### APPEAL SUMMARY

<b>Appeal ID:</b> 23427	<b>Project Address:</b> 3330 SE 69th Ave
<b>Hearing Date:</b> 2/5/20	<b>Appellant Name:</b> Tim Ayersman
<b>Case No.:</b> B-018	<b>Appellant Phone:</b> 971-200-7213
<b>Appeal Type:</b> Building	<b>Plans Examiner/Inspector:</b> John Cooley
<b>Project Type:</b> commercial	<b>Stories:</b> 3 <b>Occupancy:</b> E, B, A-2, A-3 <b>Construction Type:</b> II-B
<b>Building/Business Name:</b> Portland Public Schools - Kellogg Middle School	<b>Fire Sprinklers:</b> Yes - Fully-sprinklered throughout
<b>Appeal Involves:</b> Erection of a new structure	<b>LUR or Permit Application No.:</b> 19-130649-CO
<b>Plan Submitted Option:</b> pdf [File 1]	<b>Proposed use:</b> Middle School (Grades 6-8)

#### Appeal item 1

**Alternate 1 hour fire rated fire wall assembly with engineering analysis: Hold for additional information. Appellant may contact John Butler (503 823-7339) with questions.**

S-606

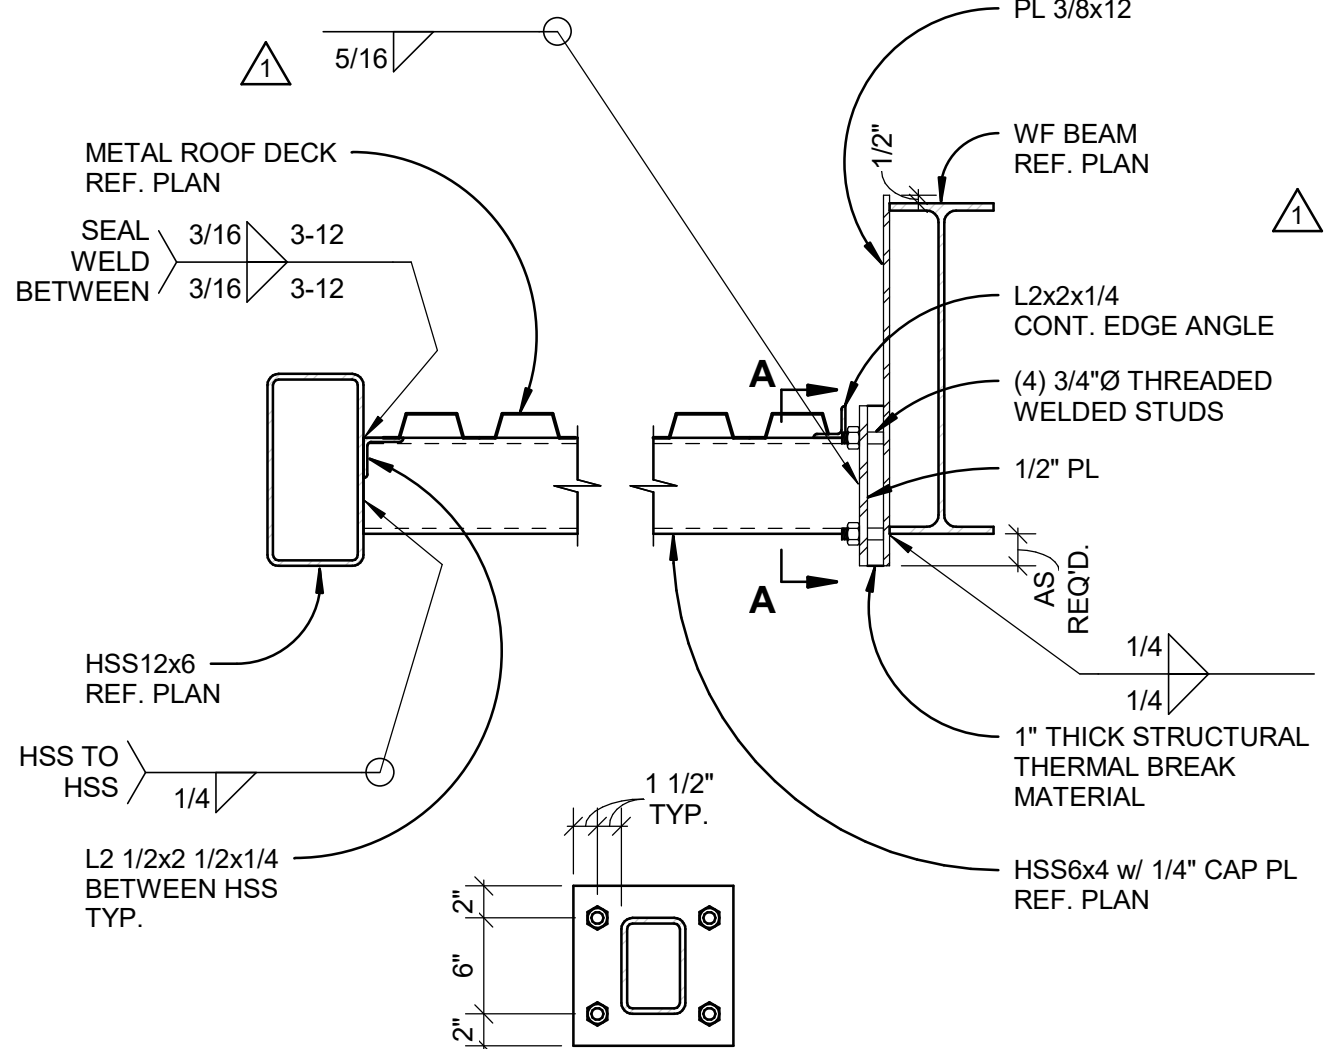
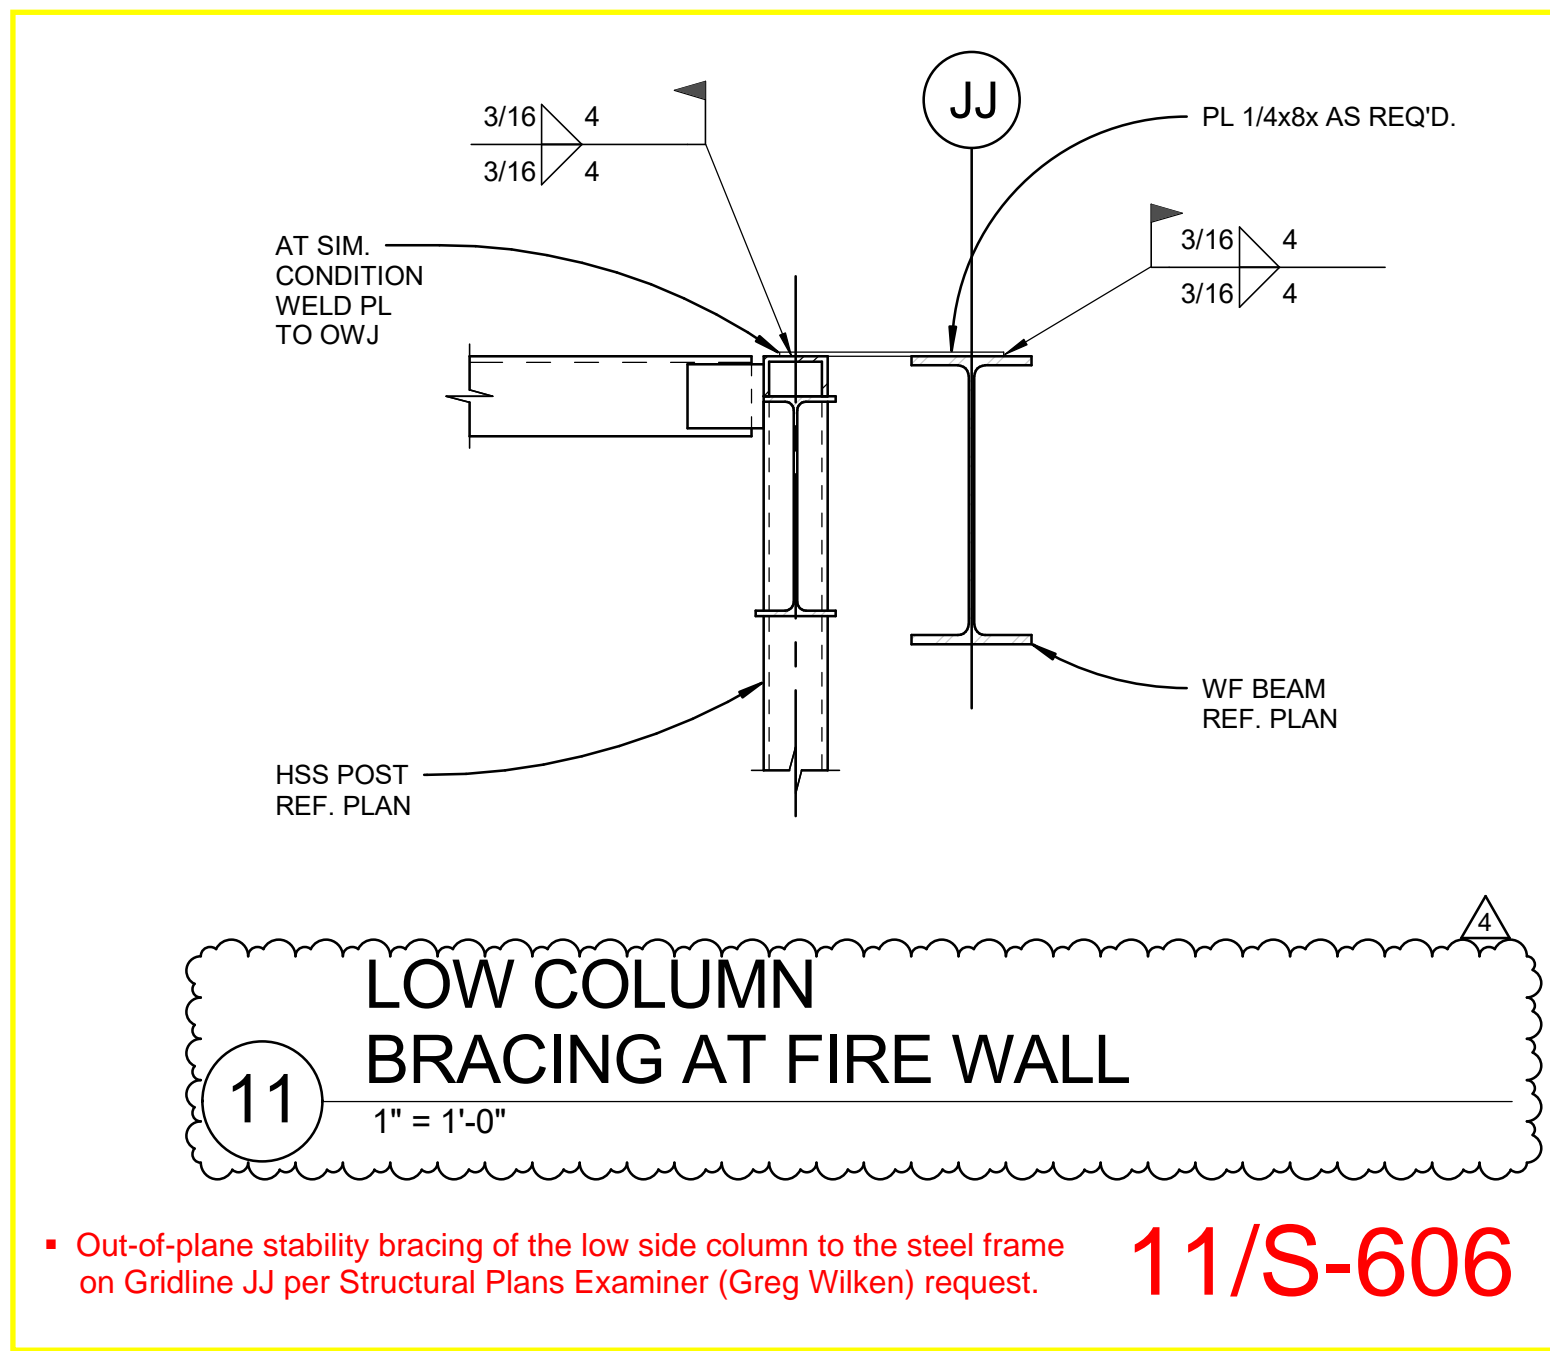
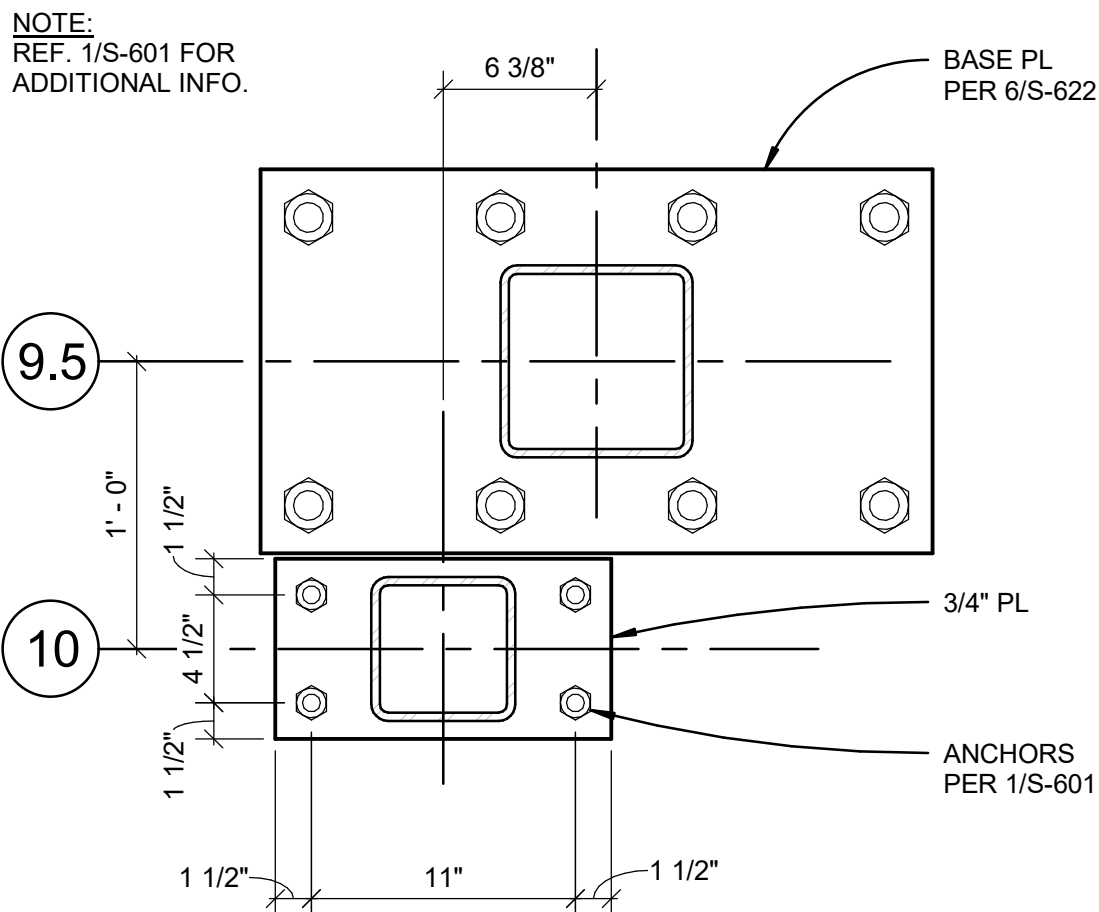
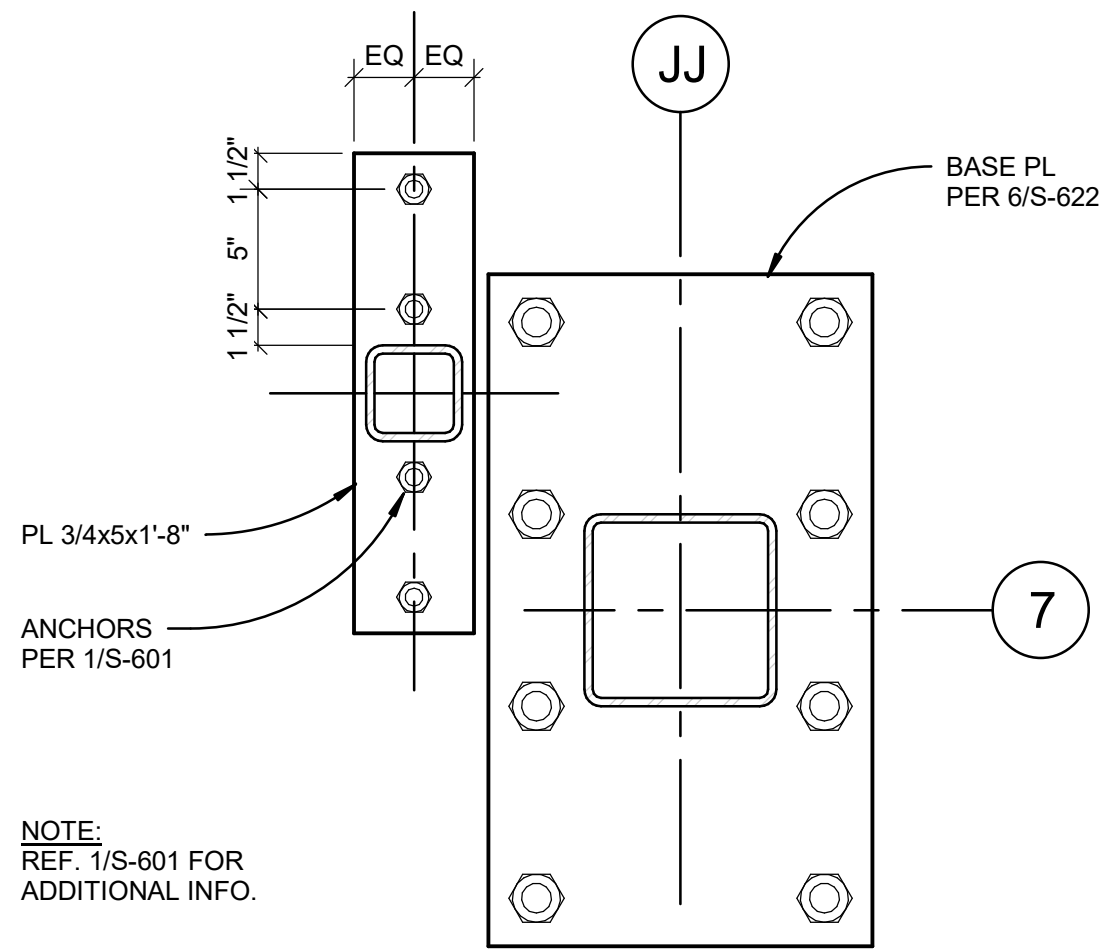
? Out-of-plane stability bracing of the low side column to the steel frame on Gridline JJ per Structural Plans Examiner (Greg Wilken) request.
